Interactive comment on “Modelling the hydrological interactions between a fissured granite aquifer and a valley mire in the Massif Central, France” by Arnaud Duranel et al.

Received and published: 7 August 2020

Fig. 1. Selected Electrical Tomography Resistivity transects across the study site. The transect locations are shown on Figure 1.

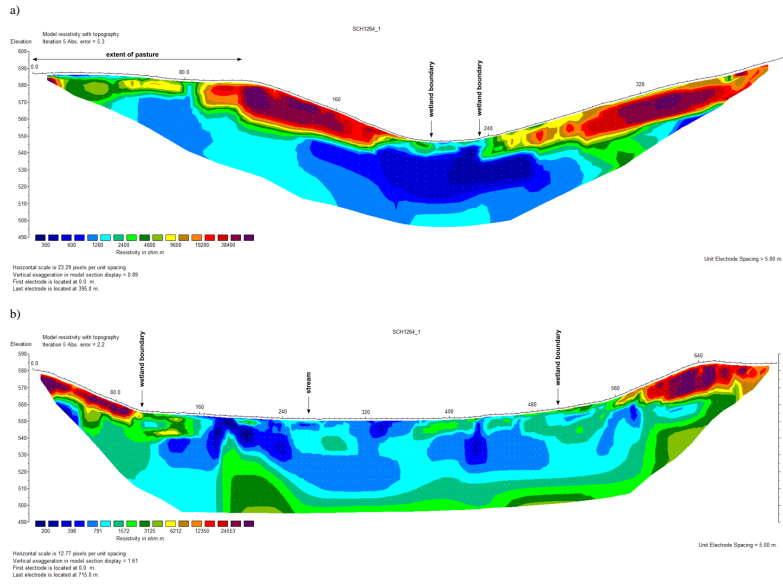
Figure 1 of this reply shows the presence of conductive material underneath much more resistive material on the hilltops and slopes of the catchment. The transition between these layers is abrupt and its altitude is largest beneath hilltops. The depth of the transition is larger beneath steep slopes, and on all transects it intersects the surface topography in the valley precisely where the wetland boundary is located (taking into account the ERT positional accuracy). The only location where conductive material was recorded above resistive material is on one hilltop (visible on the left-hand side of transect a). This was interpreted as demonstrating that most of the material investigated corresponds to the densely fissured layer of a truncated granite weathering profile. The interface between resistive and conductive material was assumed to correspond to the groundwater table (the exfiltration of which led to the formation of the wetland). The increase in resistivity with depth at the very bottom of transect b) at a depth of around 55m below ground level was interpreted as a decrease in fissure density (and therefore bulk porosity), and a transition towards unweathered granite. The superficial conductive material on the hilltop was assumed to be (probably unsaturated) saprolite, which is more conductive than the fissured granite layer due to its larger clay and water contents. The configuration was not seen anywhere else within the study area, leading to the conclusion that on most hilltops and hillslopes the majority of saprolite has been eroded away and the combined thickness of the soil, periglacial deposits and remaining in-situ saprolite is too small (less than a metre) to be detected. There is no indication of the presence of a substantial saprolite layer in the valley bottom beneath the wetland, however the complete saturation of the profile may make the distinction between fissured granite and saprolite impossible in this area. Figure 2 of this reply shows that the granite is weathered to highly weathered, with dense fissuration leading to low or variable core recovery percentages, to a depth of 15-65m. A substantial saprolite layer ("grus") is present in five out of seven locations. This is seemingly at odds with the apparent absence of saprolite beneath the wetland on the ERT transects located further downstream. However it should be noted that the geological drillings are not representative of the entire catchment as they were undertaken within a small

Fig. 2. Geological drillings by the Commissariat à l'Énergie Atomique, showing the granite weathering grade and the core recovery percentage. The drilling locations are shown on Figure 1.

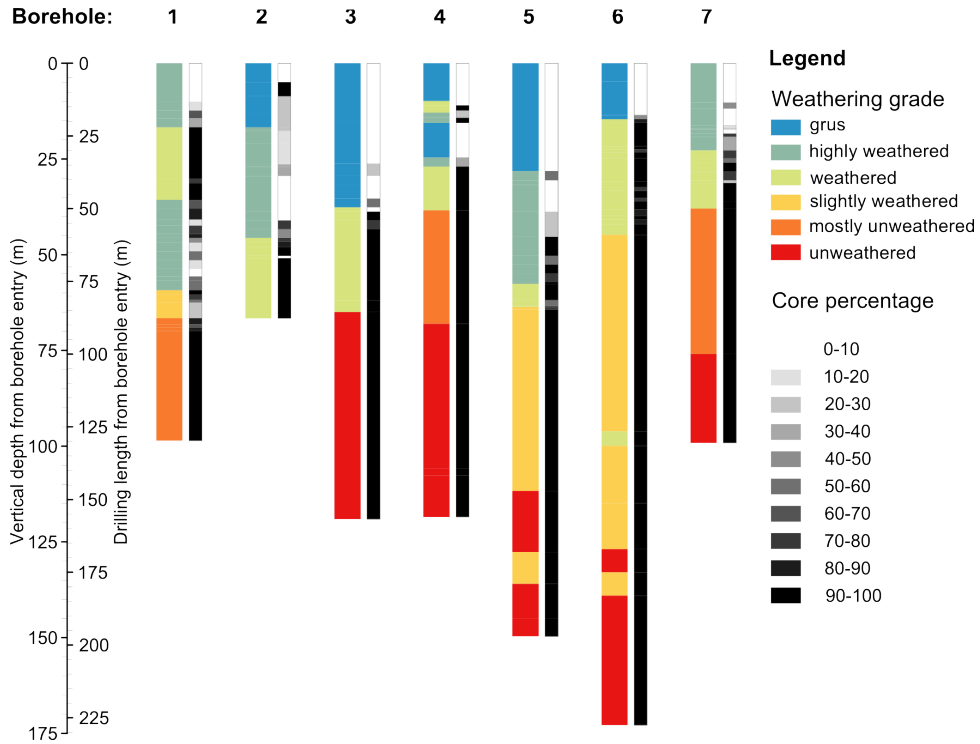
area along uranium-rich mineralised faults of tectonic origin, which may have led to a more pronounced weathering locally. Our interpretation of the ERT and geological data agrees with the current understanding of granite weathering processes, granite landscape geomorphology and granite hydrogeology in the Massif Central in general and in the Monts d'Ambazac specifically (Desire-Marchand and Klein, 1986; Dewandel et al., 2006; Godard et al., 2001; Klein, 1978; Klein et al., 1990; Mauroux et al., 2009).

Fig. 3. Simulated mean annual groundwater table depth and seepage rates in the wettest (January) and driest (September) months (2001–2013).

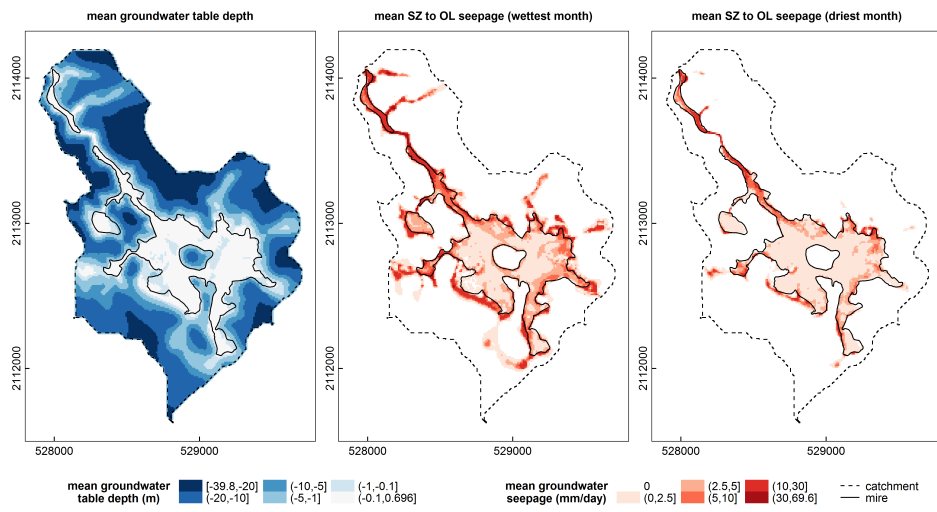
Figures 10 and 11. We believe that Figure 11 is interesting in showing the progressive decline in the seepage rate from winter to late summer, and the almost perfect agreement between areas where seepage still occurs in September and the mire extent. We do, however, also acknowledge that the figure takes a large amount of space. Therefore we propose to move it to the Supplement. In revising the manuscript, we will follow the recommendations of Referee #2 and produce a new figure replacing Figures 10 and 11 in the main paper. As recommended, this figure will show the mean groundwater table depth, and the mean seepage rates in the driest and wettest months. Figure 3 of this reply provides a draft of the proposed new figure.
